FREDERICK COUNTY PLANNING COMMISSION

TITLE: Rick Messner Subdivision

FILE NUMBER: M-3166, AP 17214 (APFO N/A, FRO N/A)

REQUEST: **Sketch Plan (Non-Binding Approval)**
The Applicant is requesting non-binding Sketch Plan approval for a 2-lot subdivision to be served by a 2,330 foot long panhandle.

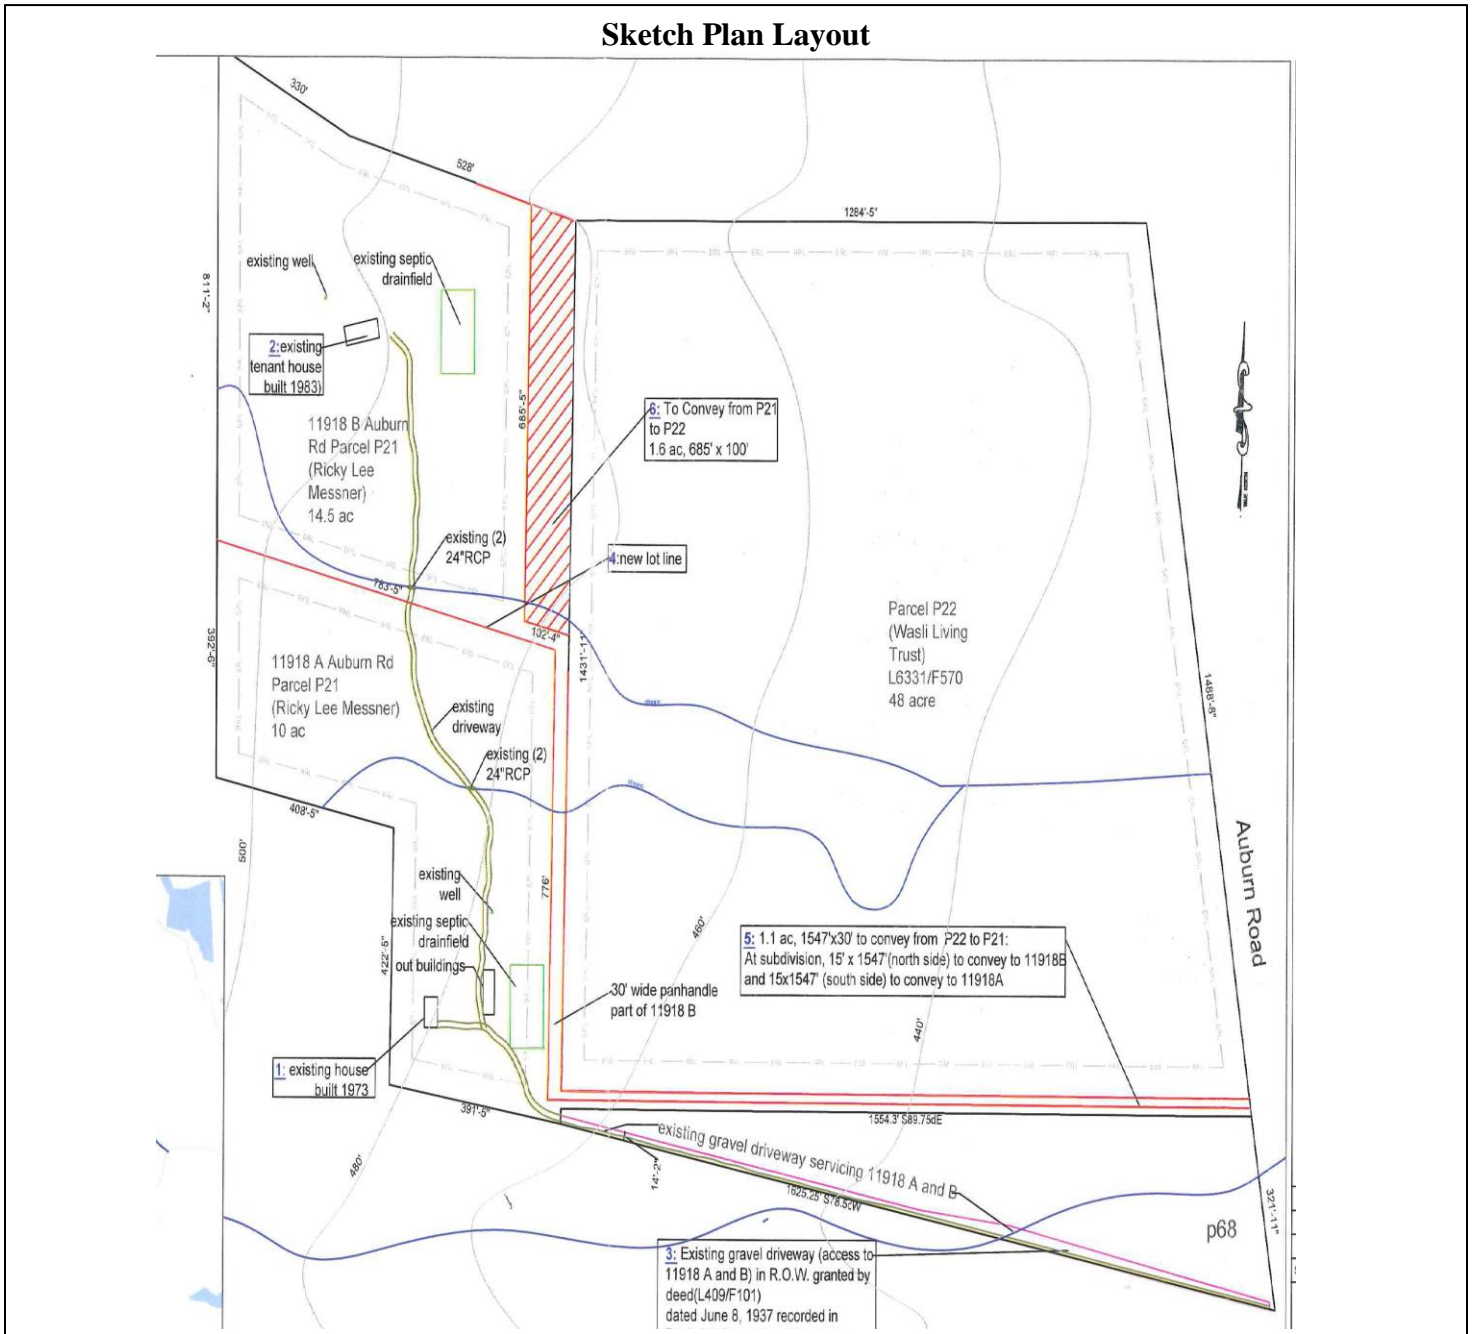
The Applicant proposes to access the lots via Auburn Road, which is an existing local road as identified on the County Comprehensive Plan. Auburn road exceeds the 16 foot width requirement for servicing minor subdivisions. The parcel is currently landlocked, meaning it does not have fee-simple road frontage. All new lots must have fee-simple road frontage to a County or State maintained public road in accordance with §1-19-4.520 of the Zoning Ordinance. The Applicant proposes to add 1.10 acres from the adjoining Parcel 22 (owned by the Wasli Living Trust) to Parcel 21 in order to obtain the required road frontage to Auburn Road. This added acreage will be divided into two panhandles to serve the two proposed lots. The panhandle that will serve the principal dwelling will be approximately 1,554 feet long. The panhandle proposed to serve the existing tenant house will be 2,330 feet in length.

The two existing houses on Parcel 21 currently use an existing 14+/- foot wide common driveway that is located on and shared with Parcel 68. A deed recorded in 1937 (L.409 F.101) grants Parcel 21 a perpetual right of way over this driveway. Although the proposed panhandles are not located over this driveway, the Applicant proposes to continue using this existing driveway.

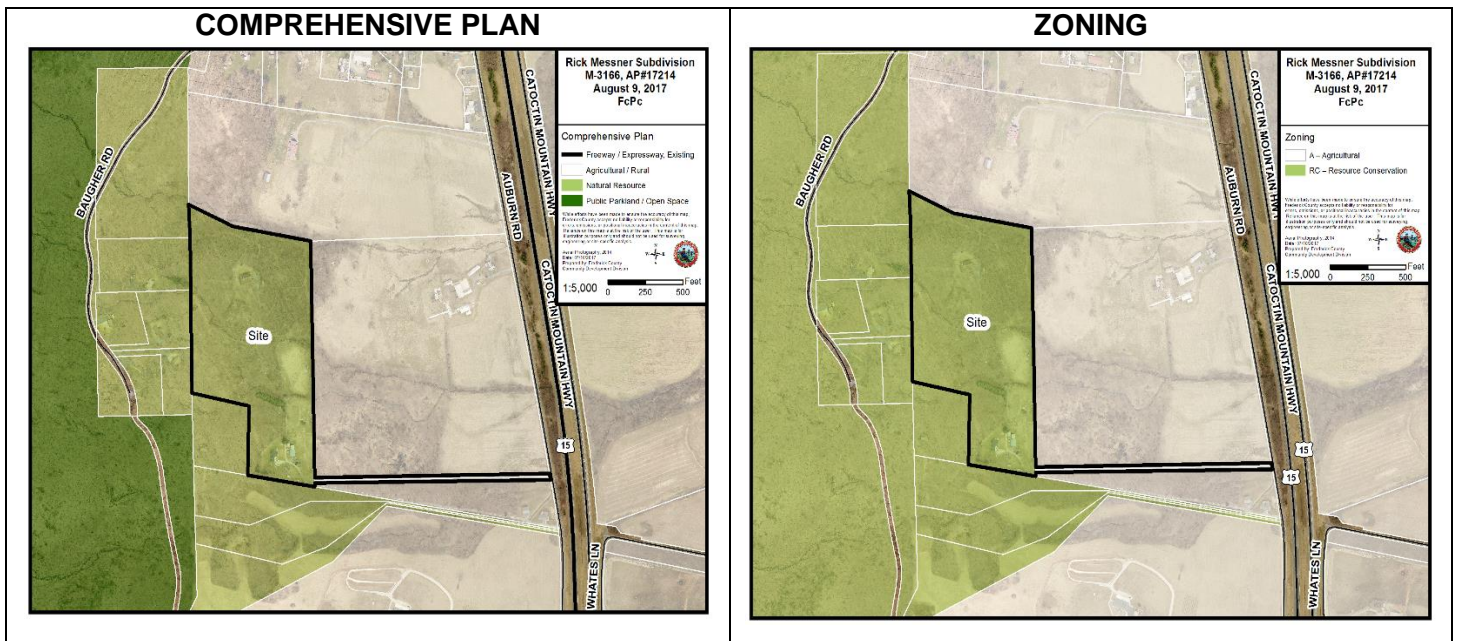
Both of the proposed lots meet the minimum 10 acre lot size requirement. The proposed minimum lot width (300 feet) and yard areas (50 foot front yard, 50 foot rear yard, and 50 foot side yard) meet Resource Conservation District requirements in accordance with §1-19-6.100 Design Requirements of the Zoning Ordinance. The lots range in size from 10 acres to 14.50 acres.
